# UNITED STATES PATENT AND TRADEMARK OFFICE

APPLICATION NO.	FILING DATE	FIRST NAMED INVENTOR	ATTORNEY DOCKET NO.	CONFIRMATION NO.
10/017,745	12/14/2001	Essam Sourour	040071-482	8805
42015	7590	11/13/2006	EXAMINER	
POTOMAC PATENT GROUP, PLLC P. O. BOX 270 FREDERICKSBURG, VA 22404			TAYLOR, BARRY W	
			ART UNIT	PAPER NUMBER
			2617

## Office Action Summary

## DETAILED ACTION

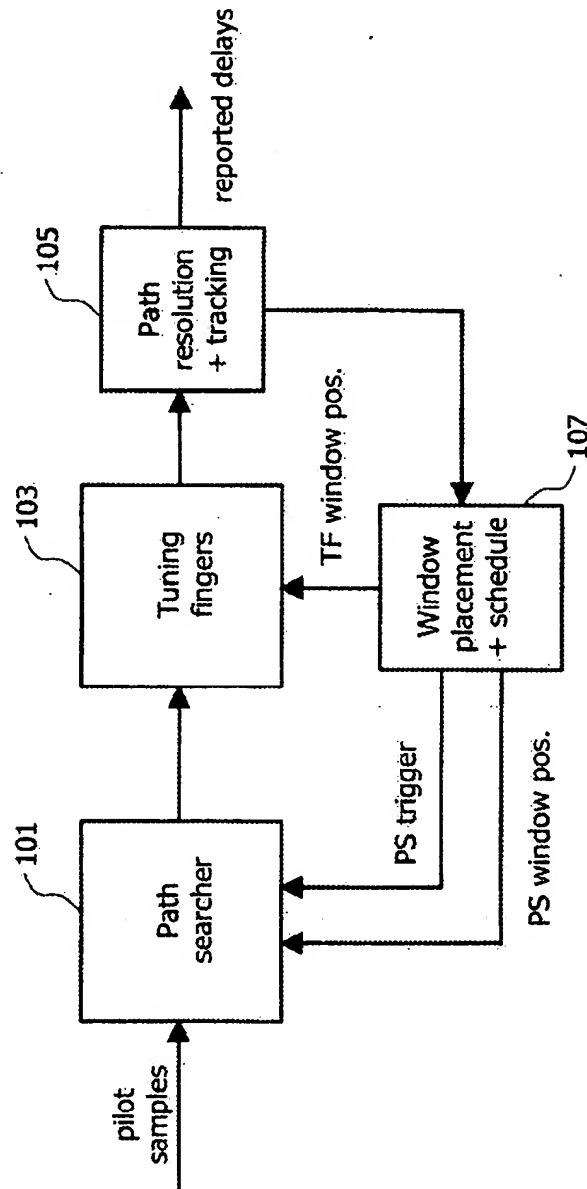
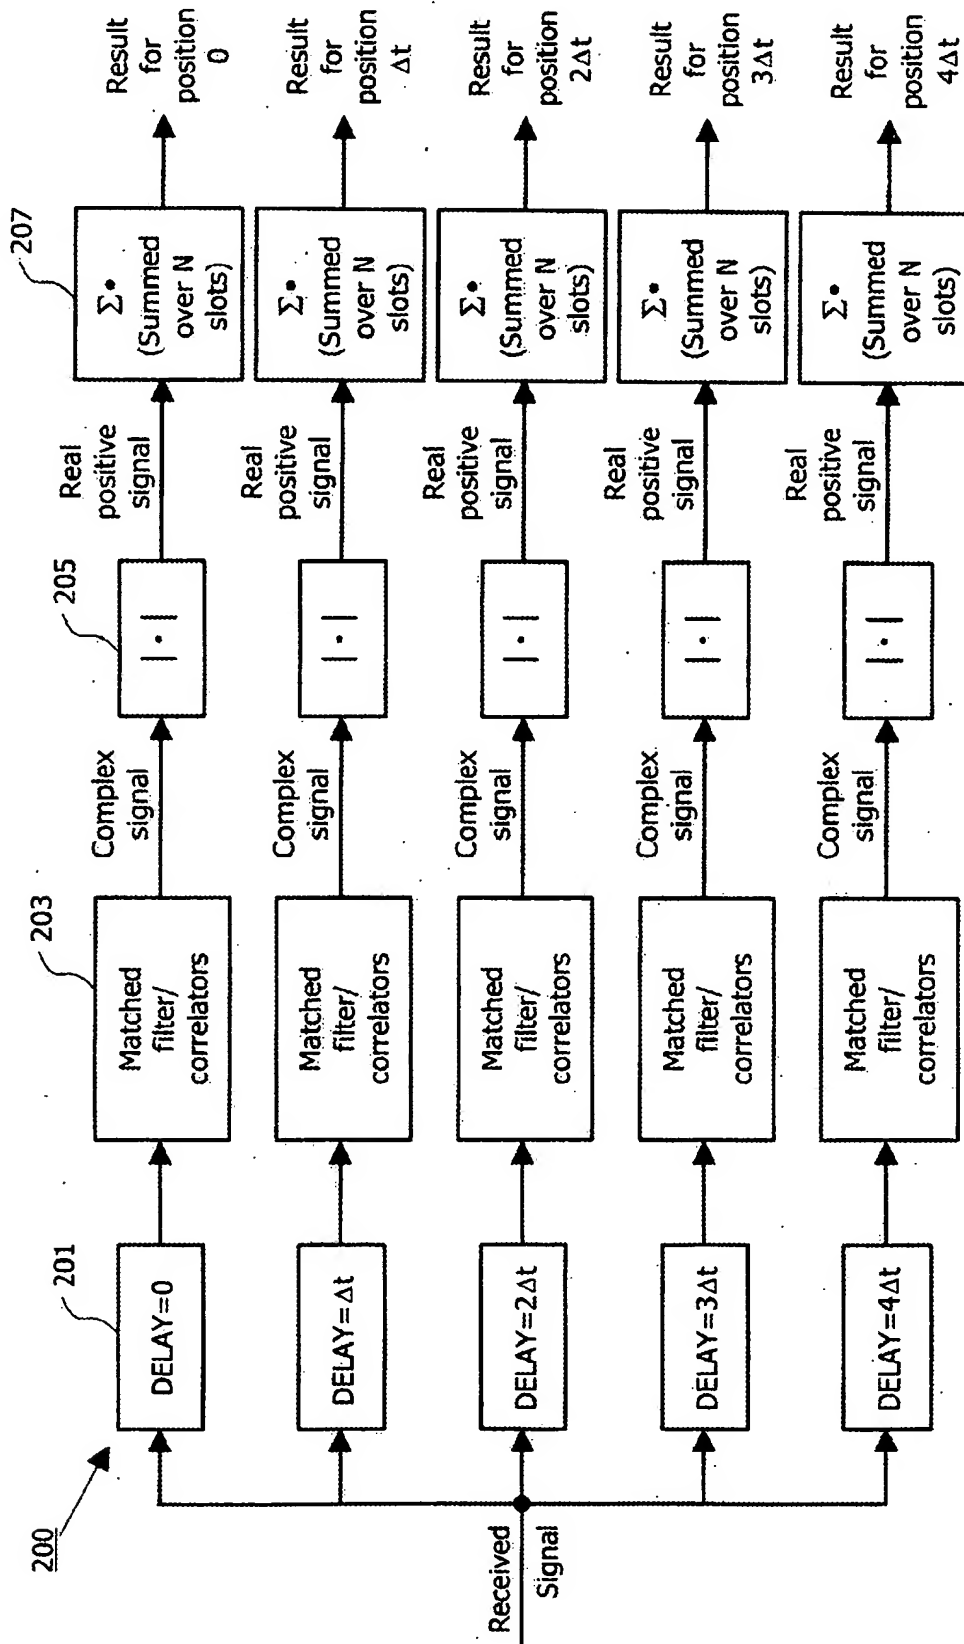
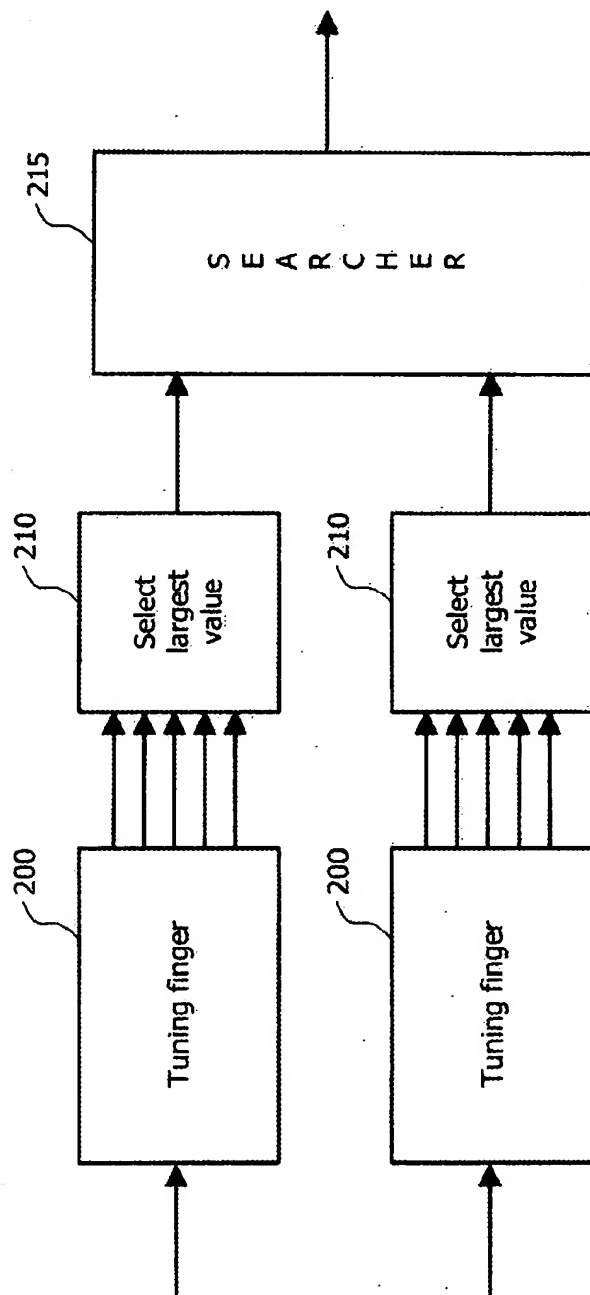
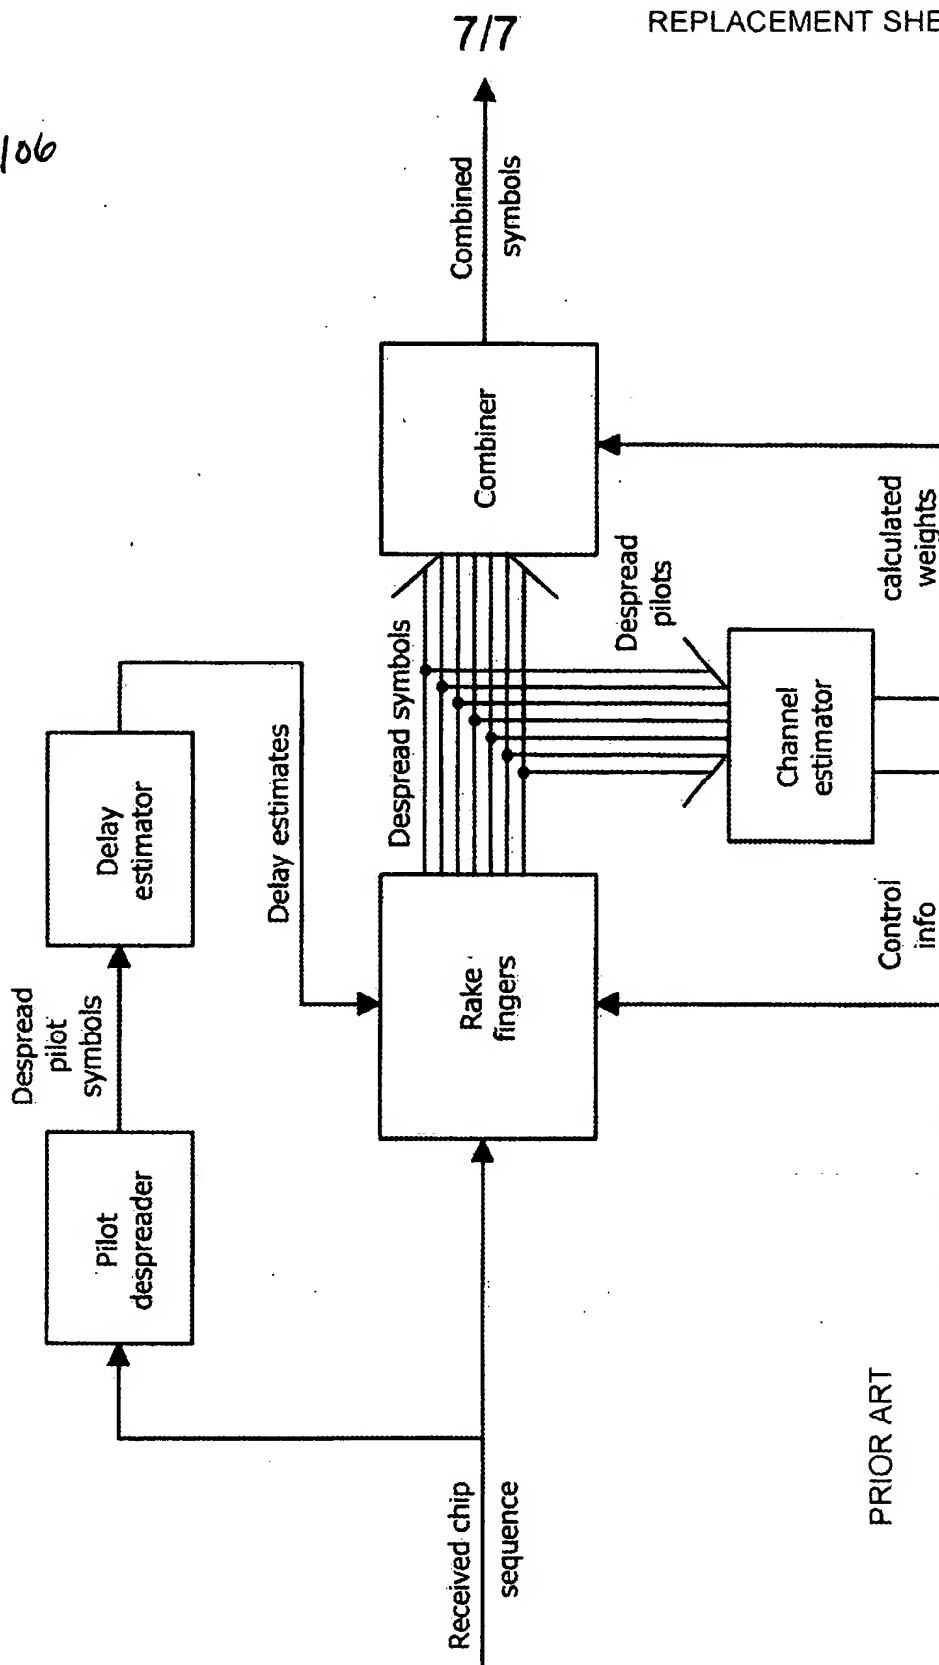
Madhow does not explicitly show obtaining interfering component to be subtracted out (see difference between Applicants admitted prior art (i.e. figures 1-3 and 7) and Applicants figure 6 (i.e. item 510---interference calculation and subtraction)).
